March 12, 2014

Re: 14CVCP157K
1035 Fulton Street
Brooklyn, NY
Remedial Action Work Plan (RAWP) Stipulation List

Environmental Business Consultants (EBC or the consultant) hereby submits a Remedial Action Work Plan (RAWP) Stipulation List for the 1035 Fulton Street (the Site) to the New York City Office of Environmental Remediation (OER) on behalf of Fulton Hill Corner LLC. This letter serves as an addendum to the RAWP to stipulate additional content, requirements, and procedures that will be followed during the Site remediation. The contents of this list are added to the RAWP and will supersede the content in the RAWP where there is a conflict in purpose or intent. The additional requirements/procedures include the following Stipulation List below:

FIGURE 6

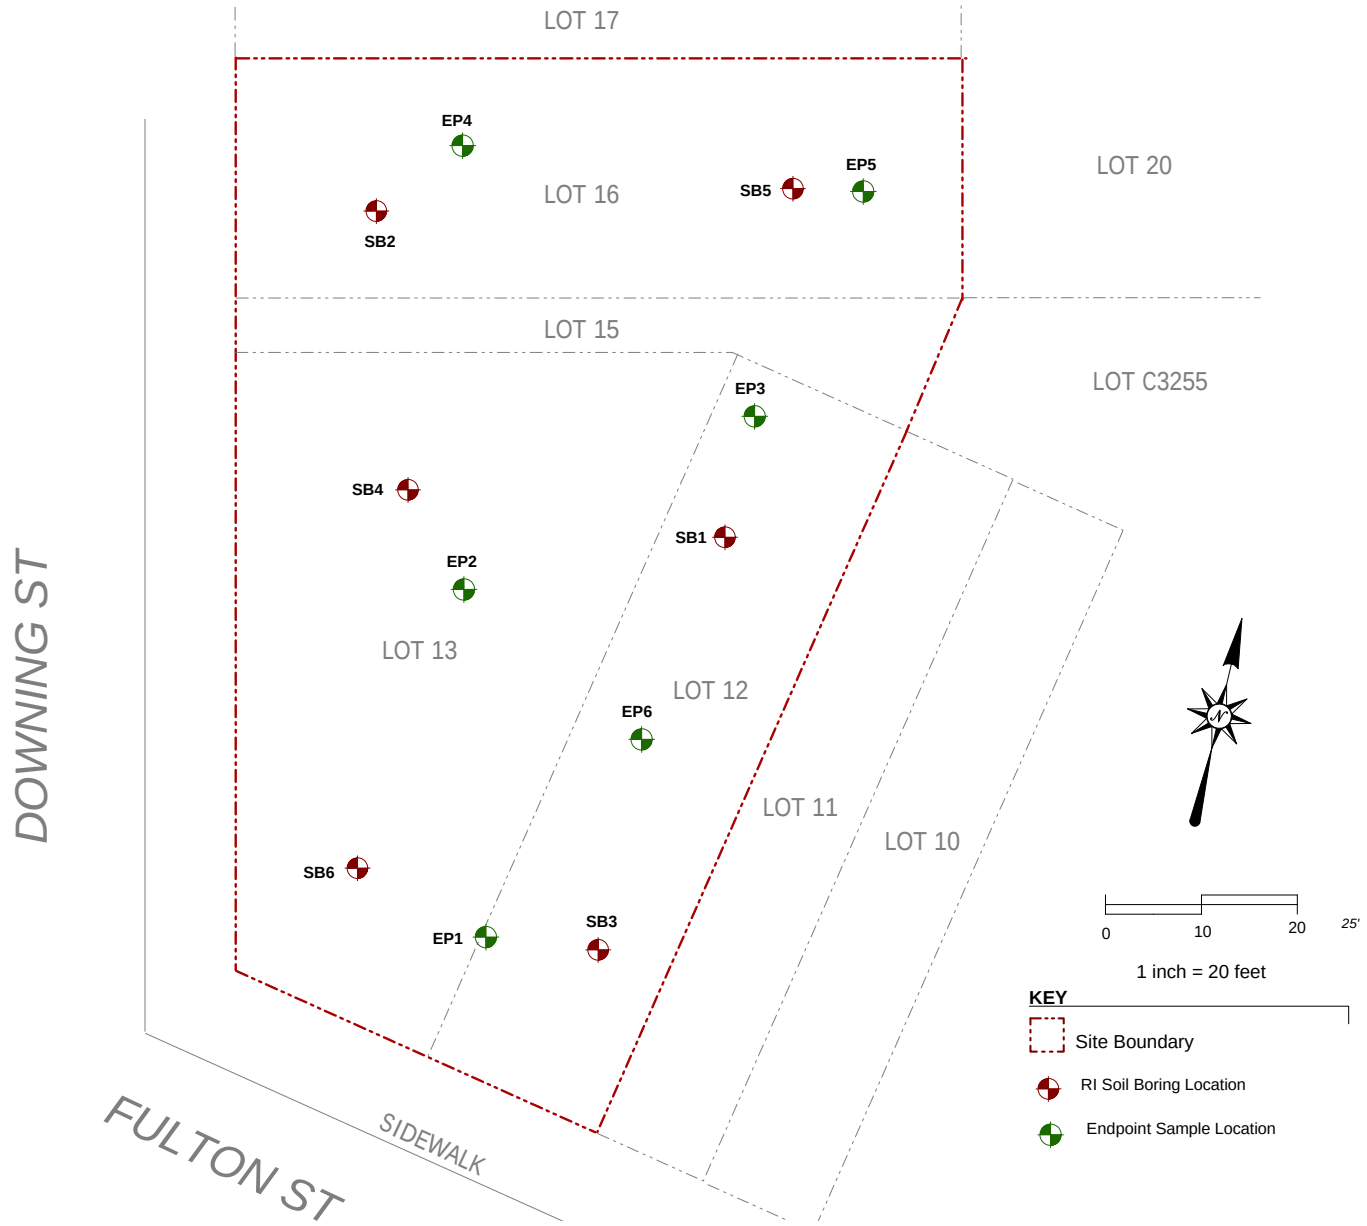
7. Collection and analysis of six post-excavation samples from the bottom of the excavation will be collected to evaluate the performance of the remedy with respect to attainment of Track 1 SCOs. Figure

6 indicating End point post-excavation sampling locations is attached in **Appendix 3**. Samples will be analyzed for contaminants of concern (SVOCs, pesticides and metals (lead, mercury and zinc).

FIGURE 1 TRUCK ROUTES

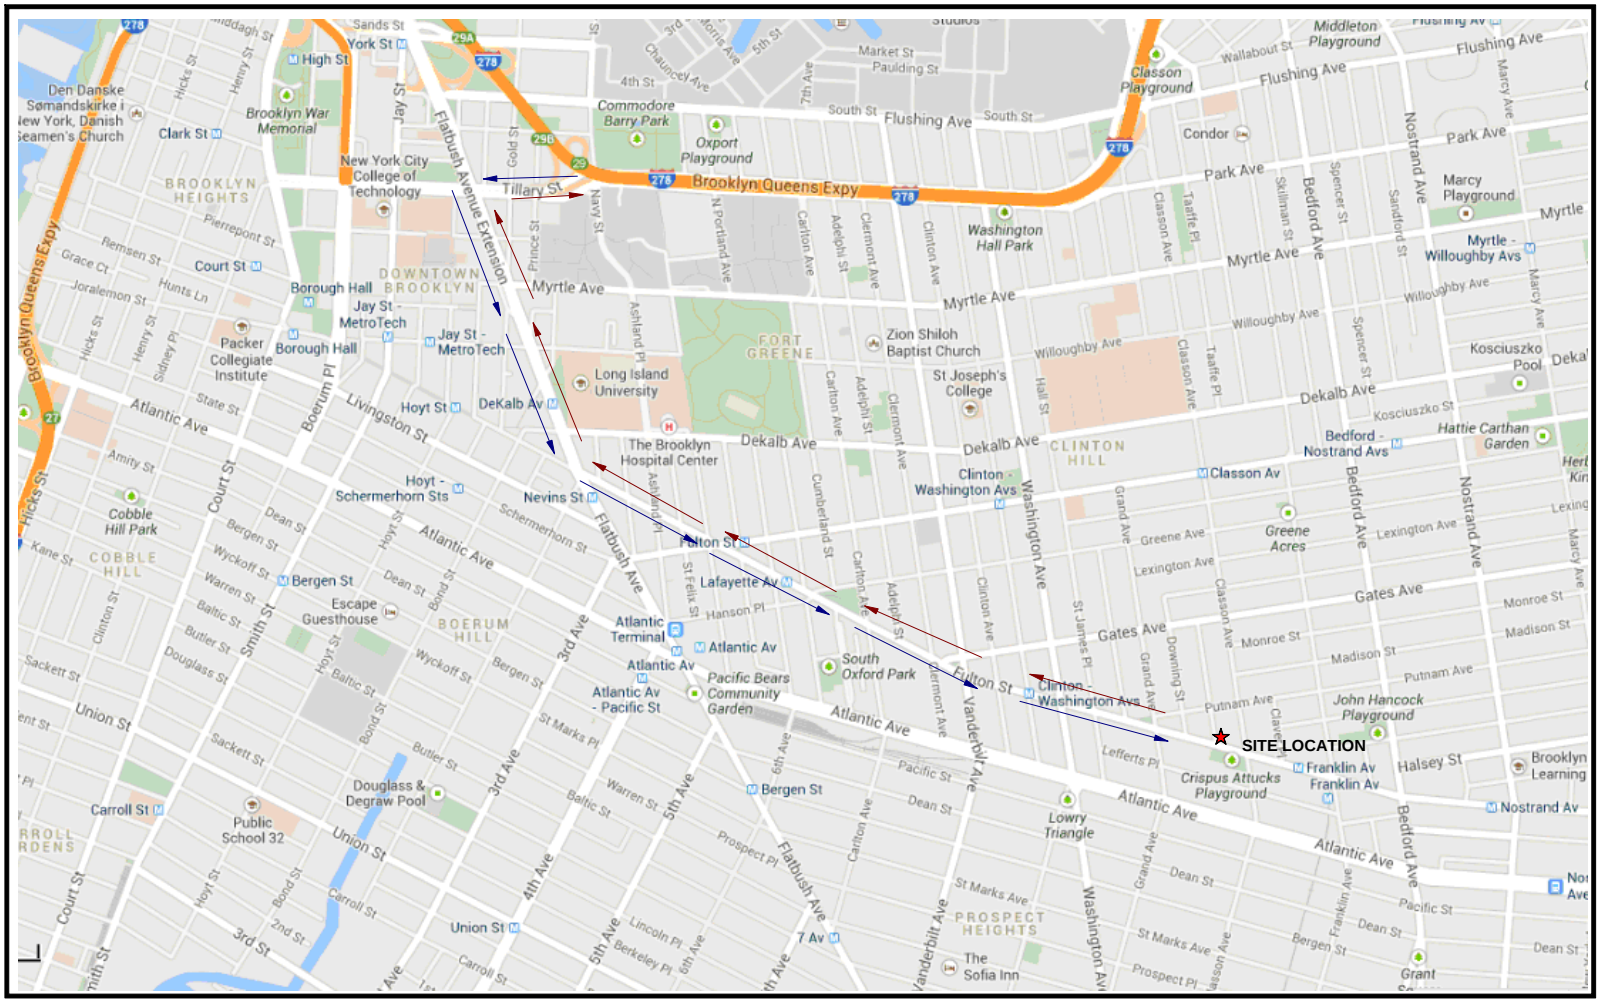
8. Truck route is included in **(Appendix 4**).

CELLAR PLAN
GROSS AREA: 6,339.5 S.F.
SCALE: 1/4" = 1'-0"
T.O.C. EL. = +56.54' [-10'-0"]

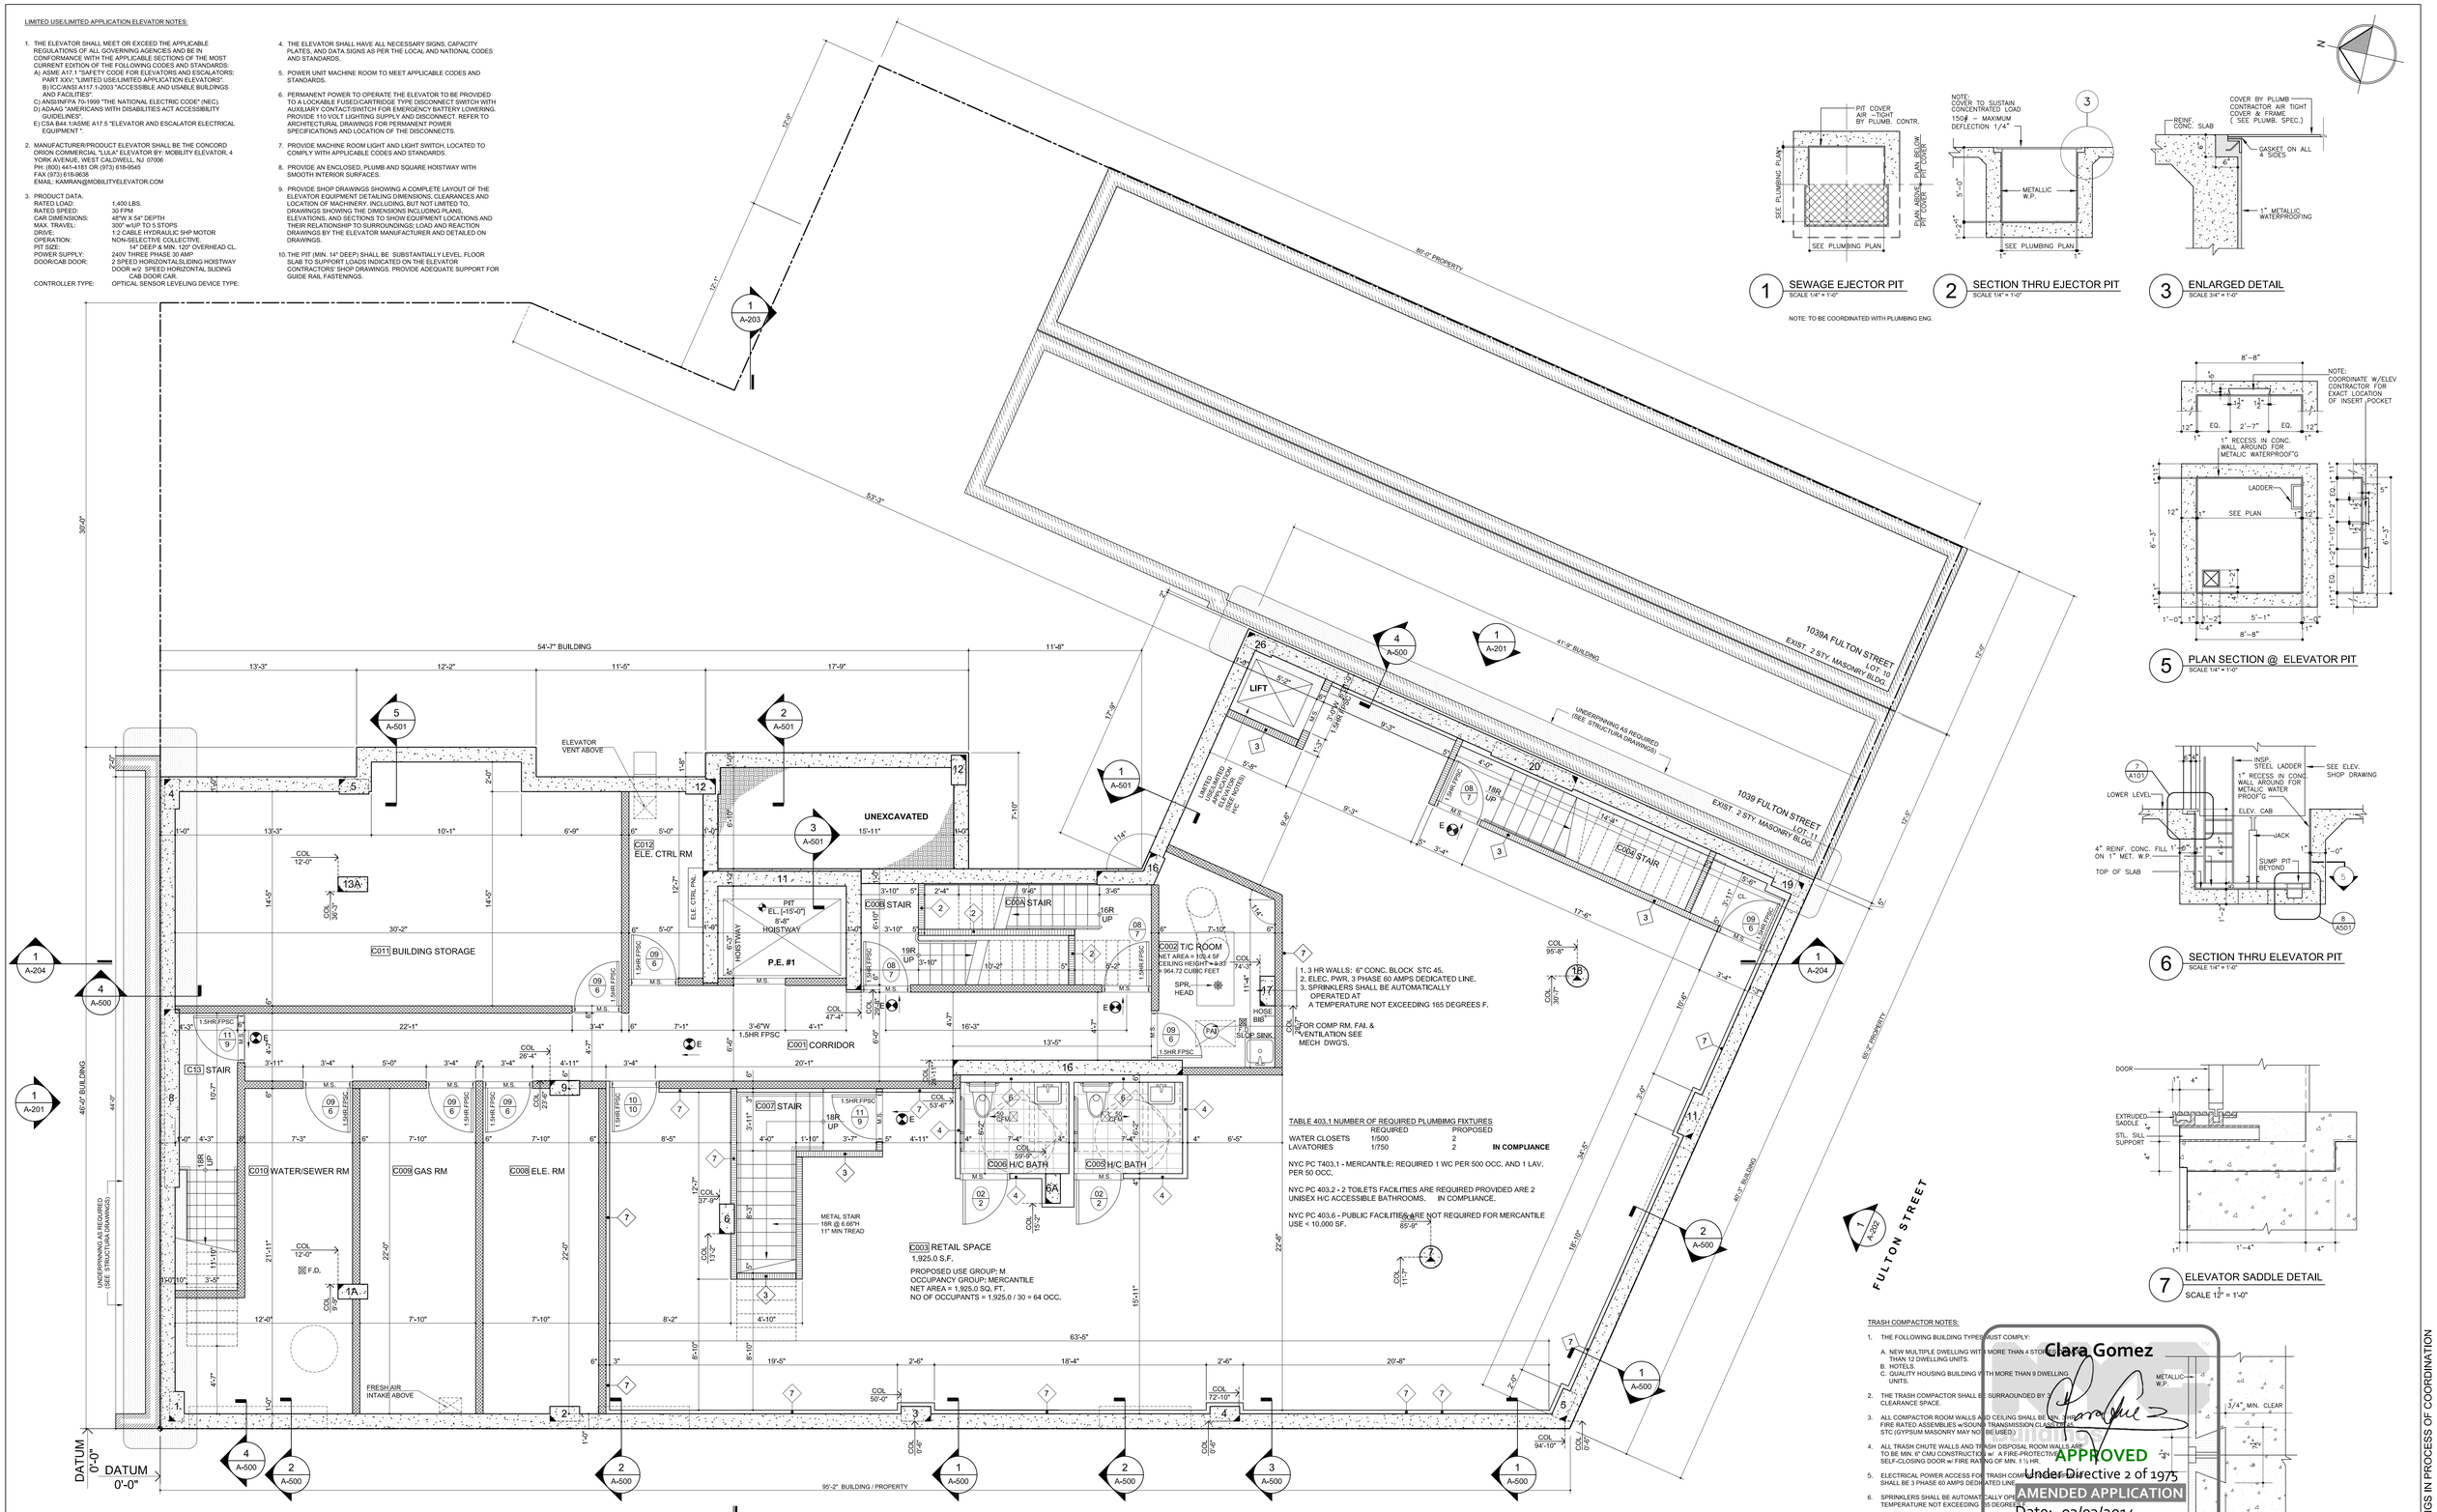
13. Revised project description: The proposed future use of the Site will consist of a new 7-story mixed use building. The proposed building will occupy approximately 85% of the Lot and will include a fill cellar. The remaining portions of the Lot will be capped with concrete and utilized as outdoor recreational space. The cellar will be used for commercial space, recreation, storage and utility rooms. Access to the basement is provided via stairwell and elevator. The first floor will be used for commercial and residential recreation space, residential lobby and bicycle storage. The second through seventh floors will all be residential units. The top of the cellar floor will be approximately 10 feet below sidewalk level, requiring excavation of the 85% of the Lot to approximately 11 feet below grade, with additional excavation for the elevator pit to approximately 15 feet below grade. The updated site plans are included in **Appendix 9**.
